RE: MINOR AMENDMENT – BELLISIMA PUD (Z-36-12-2)

> Minor Planned Unit Development (PUD) Amendment Meritage Homes/Bellisima (Z-36-12-2) SWC | 56th Street & Dixileta Drive

PLANNED UNIT DEVELOPMENT Z-36-12-2

First Amendment Draft: December 02, 2014

BELLISIMA | CONCEPTUAL LANDSCAPE EXHIBIT

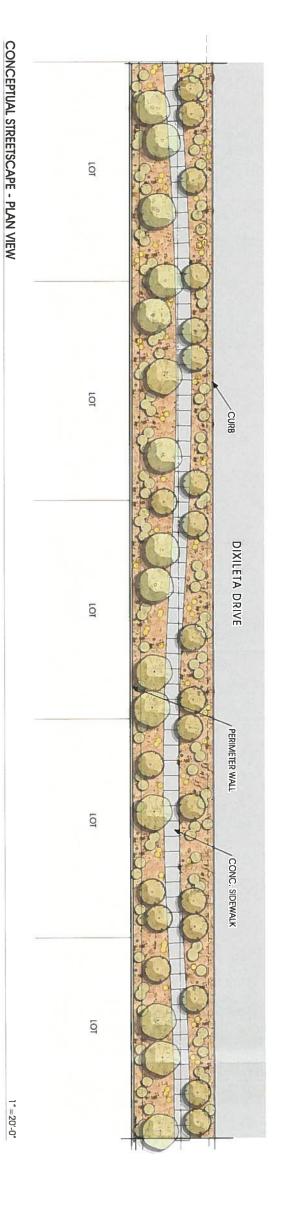
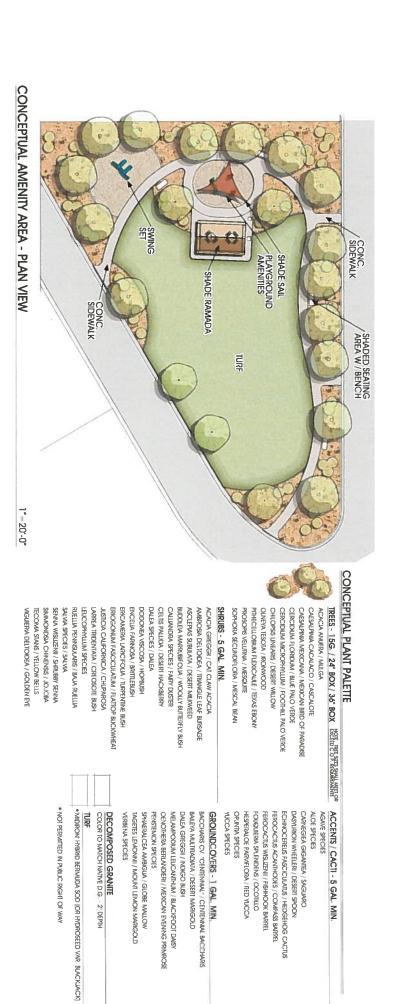
a) Section G.5 Amenities; Bellisima | Conceptual Landscape Exhibit; and, Bellisima | Conceptual Streetscape / Open Space Exhibit:

<u>Request</u>: Modify programming for active and passive open space recreational amenities.

<u>Justification</u>: Although proposed modification to the type and amount of amenities will maintain the initial vision for the project, slight modifications of Section G.5 Amenities, Table G.501: Open Space Amenities – Bellisima, Bellisima | Conceptual Landscape Exhibit, and Bellisima | Conceptual Streetscape / Open Space Exhibit are requested to proactively respond to continued demographic analysis and corresponding open space amenity programming.

BELLISIMA | CONCEPTUAL WALL PLAN EXHIBIT

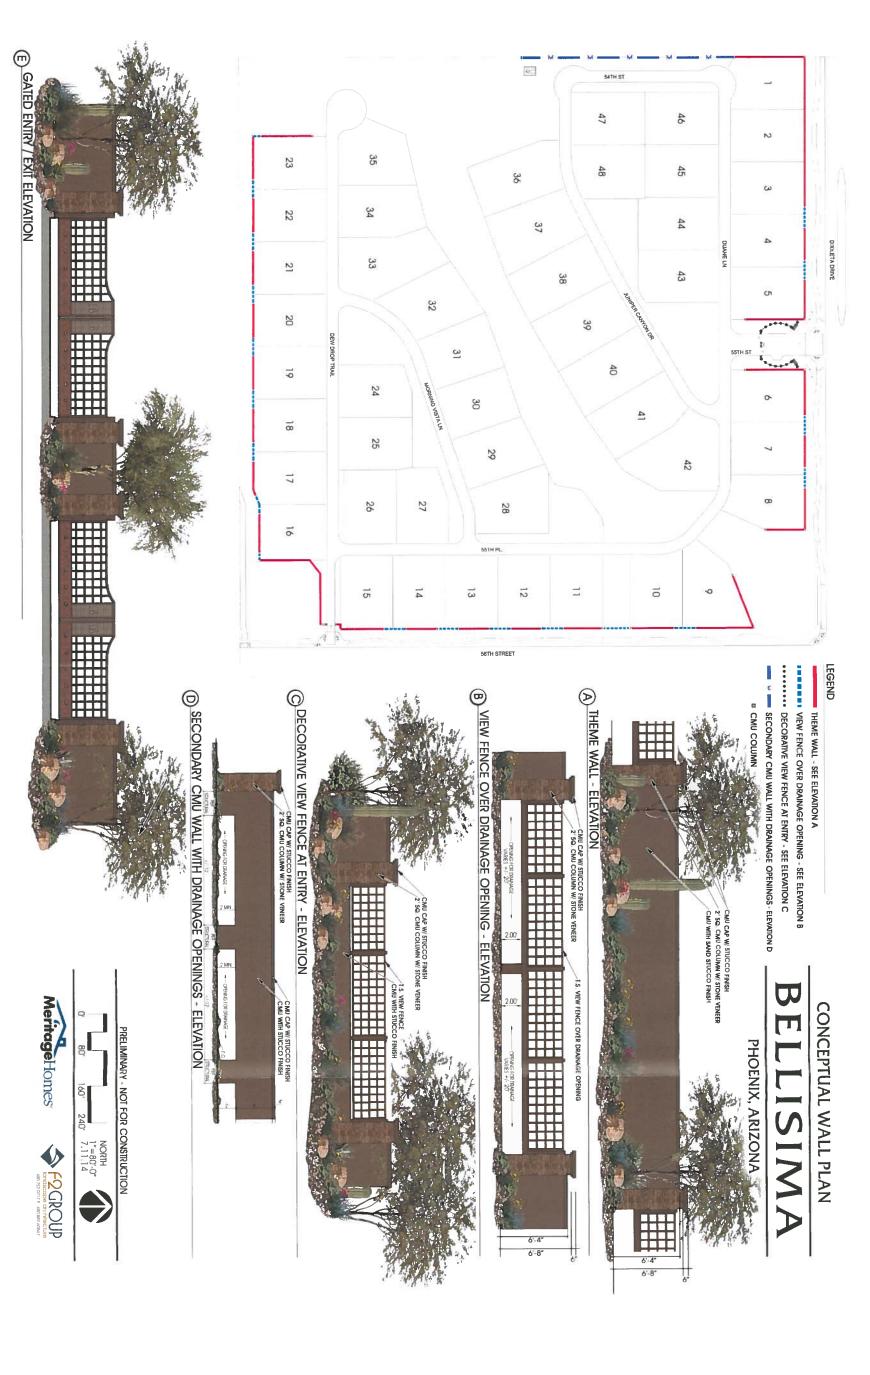
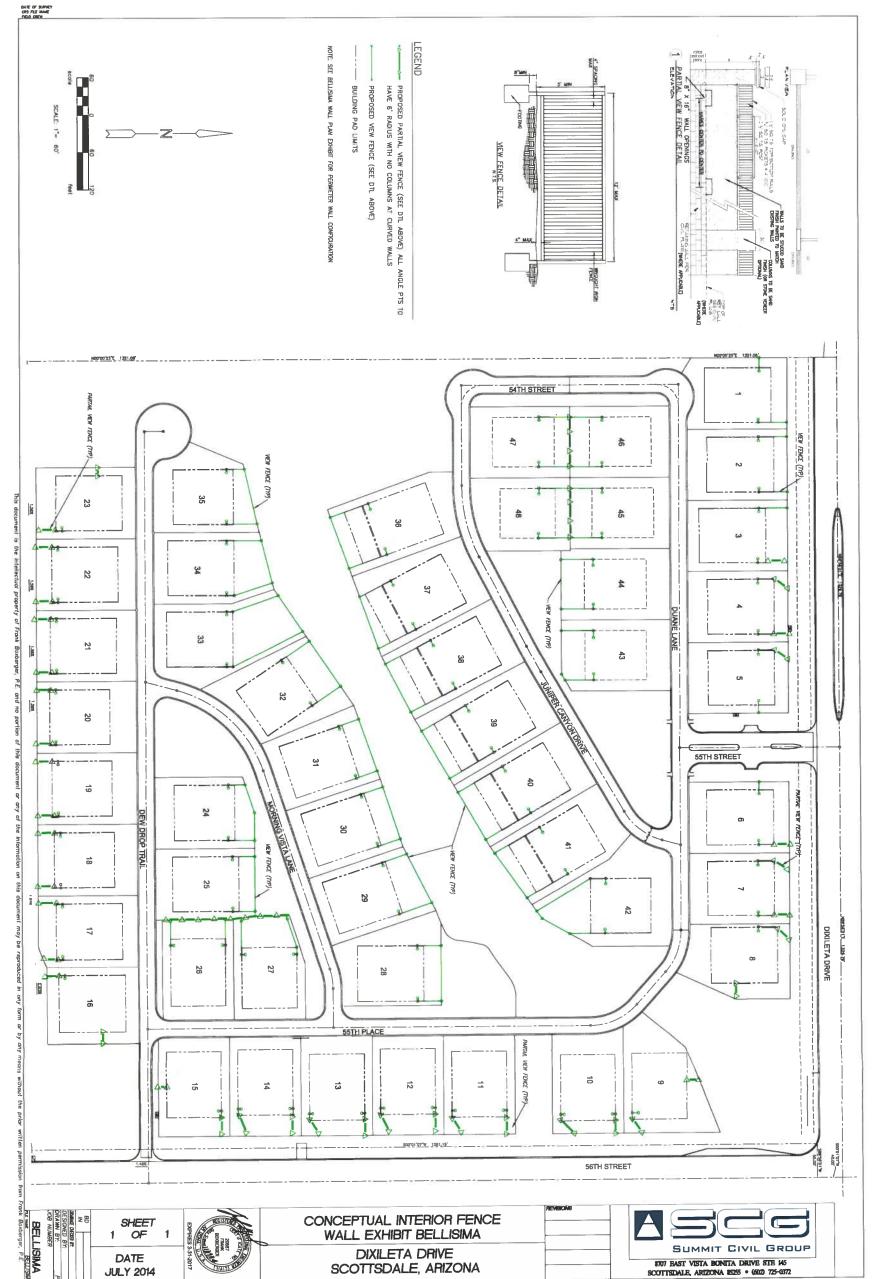
c) Section G.8.B Interior Fencing; Bellisima | Conceptual Wall Plan Exhibit:

<u>Request</u>: Modify acceptable locations for interior lot fences; and, update the Bellisima | Conceptual Wall Plan Exhibit to reflect previous administrative approvals.

<u>Justification</u>: Modification of Section G.8.B Interior Fencing is requested to adjust self-imposed restrictions on interior lot fencing and walls. With the exception of view fencing only within the building envelope, which restriction was primarily based on drainage needs of the site, interior lot fencing and fences on common lot lines is currently prohibited.

Additionally, interior lot view fencing is now proposed to encroach into some side and rear building setback areas, outside of the building envelope. Primary reasoning for modification to this previous self-imposed location restriction is to allow reasonable opportunities to attach the full view fencing to some perimeter walls (lots 1-3; and, 5-6). Further, full view fences are also proposed to connect to the abovementioned partial view fences in effort to promote continuity and address safety concerns, while location of these fences outside of the building envelope will also allow greater private use of individual rear lot areas.

- Location. Exclusive of perimeter walls, which locations are set forth in the 1... Bellisima | Conceptual Wall Plan Exhibit contained herein, iInterior walls and fencing on individual lots may only be installed in locations illustrated on the Conceptual Interior Fence | Wall Exhibit - Bellisima contained herein; and, in locations as set forth below; constructed within the side and rear building envelope.
 - i. Building Envelope. Except as permitted in Section G.8.C Screening of Mechanical Equipment; and, in locations illustrated on the Conceptual Interior Fence | Wall Exhibit – Bellisima, all other fences located within the building envelope are limited to full view type fencing.

- ii. <u>Side and Rear Building Setback</u>. Partial view fencing is permitted only within side and rear building setback locations as illustrated on the Bellisima | Conceptual Wall Plan Exhibit.
- 2. Height, Side and Rear Building Envelope. All interior side and rear fencing shall be a maximum of 8-feet in height. The height of a fence shall be measured from the higher of the adjacent finished grade elevations, which elevation shall be the average measured perpendicular within 50-feet of the fence.

- ii. <u>Interior partial view fencing shall be constructed of a combination of CMU and wrought iron. The solid portion of partial view fences shall stucco sand finish, or similar, and painted to match perimeter walls and fences.</u>
